NUMBER
DEP16193

LINE	QUANTITY	UOP	CAT. NO.	ITEM NUMBER	UNIT PRICE	AMOUNT
				ADDENDUM NO. 1		
				1. ADDENDUM ISSUED TO PROVIDE VENDORS ANSWER TO QUESTIONS SUBMITTED REGARDING THE ORIGINAL SOLICITATION.		
				2. TO PROVIDE A COPY OF THE MANDATORY PRE-BID SIGN-IN SHEETS.		
				3. TO PROVIDE A DRAWING TO REPLACE THE AFFECTED AREA IN THE VICINITY OF PORTAL 1, SHOWN ON SHEET 3 OF THE ORIGINAL DRAWINGS.		
				4. TO PROVIDE A REVISED CONTRACTOR'S BID SHEET. ALL OF THE ABOVE DOCUMENTS ARE DEFINED AS ATTACHED.		
				5. TO PROVIDE ADDENDUM ACKNOWLEDGEMENT. THIS DOCUMENT SHOULD BE SIGNED AND RETURNED WITH YOUR BID. FAILURE TO SIGN AND RETURN MAY RESULT IN THE DISQUALIFICATION OF YOUR BID.		
				END OF ADDENDUM NO. 1

**Addendum Number:** 1

**DEP16193**  
**Braeholm (Evans) Drainage & Portals**  
**Addendum #1**

**FIGURE 1**

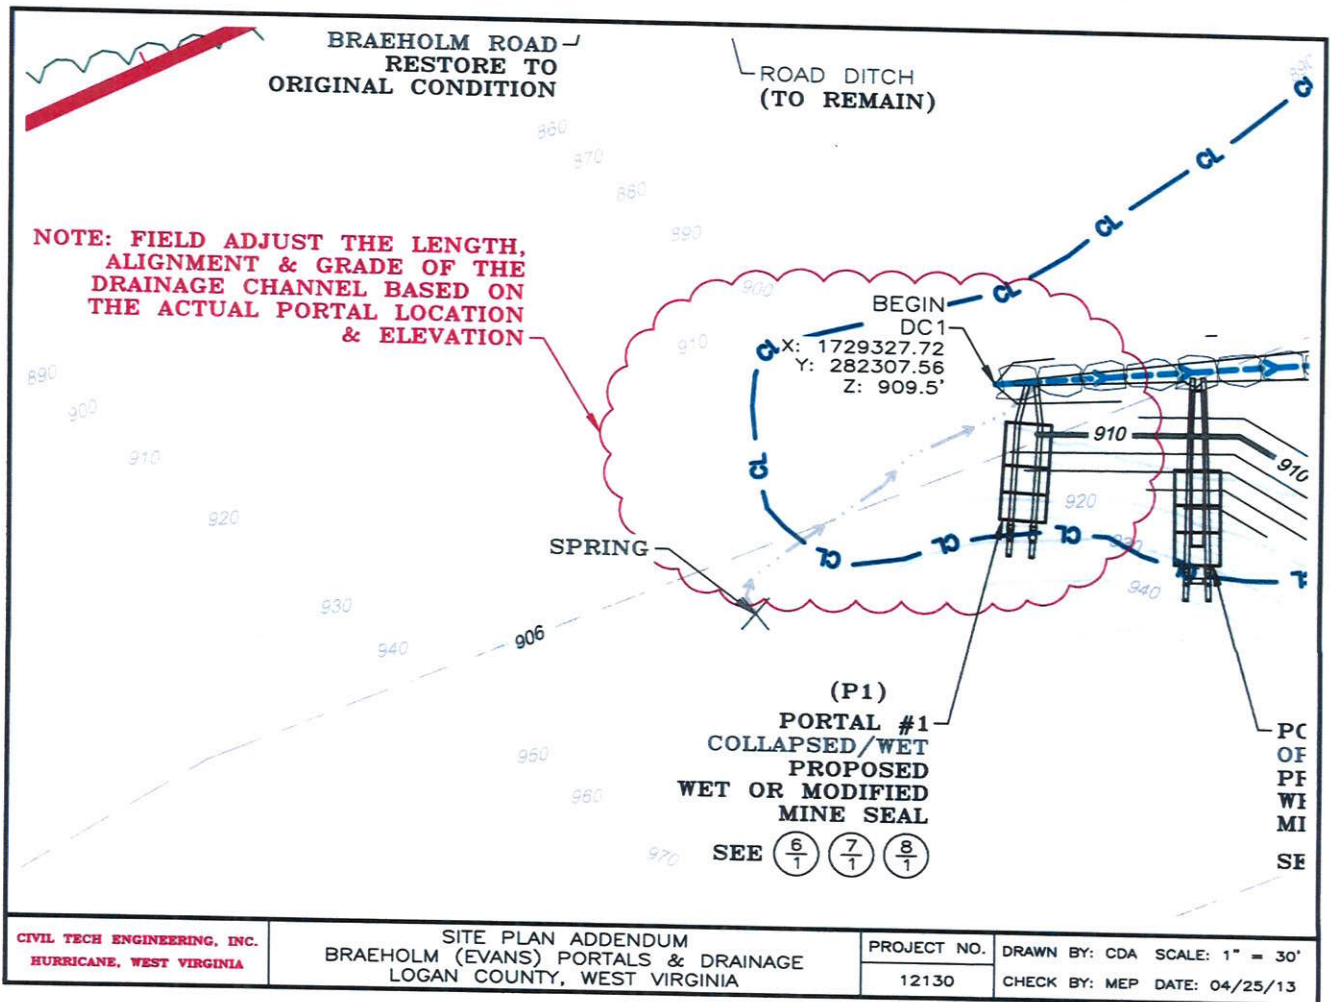
- Item 6: Q - Can the drainage from portal 1 convey to the other channels?  
A - Yes. It is intended for portal 1 to discharge into "Drainage Channel 1", as shown on sheet 3 and the Site Plan Addendum. The drainage channel profile and alignment and grade will need to be adjusted in the field as directed by the WVDEP to match the actual coal floor elevation at the entry locations.

Item 11: See Figure 1 below. This drawing is to replace the affected area in the vicinity of Portal 1, shown on sheet 3. Note that the scale is incorrect, since the drawing was reduced to fit this document.
